service bulletin

Bulletin No. 2002-13

MerCruiser Product Changes Related to SmartCraft

Typical ECM Calibration Label

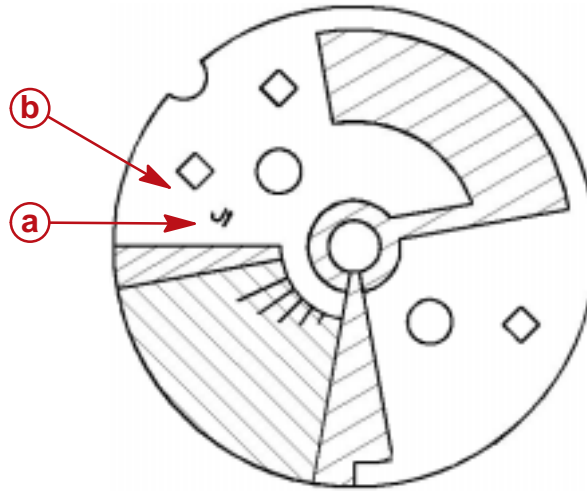
When connecting a SmartCraft instrumentation system to an affected model or when replacing an ECM on a unit connected to a SmartCraft instrumentation system, it is necessary that the correct base ECM module/trim sender rotor combination is used. The trim sender rotor can be identified by a 2-digit code on the rotor. The base ECM module part number appears on the identification label on the ECM module.

All replacement ECM 555 modules for MerCruiser products now use base ECM module P/N 864916. When replacing an ECM on an affected model that is equipped with SmartCraft instrumentation, it may be necessary to replace the trim sender rotor. If the base ECM part number is the same on both the existing and replacement ECM's, and the trim gauge functions properly, then the trim sender rotor does not need to be replaced. The trim sender rotor must be changed **ONLY IF** the base ECM module part number on the new ECM is different than the base ECM module part number on the old ECM.
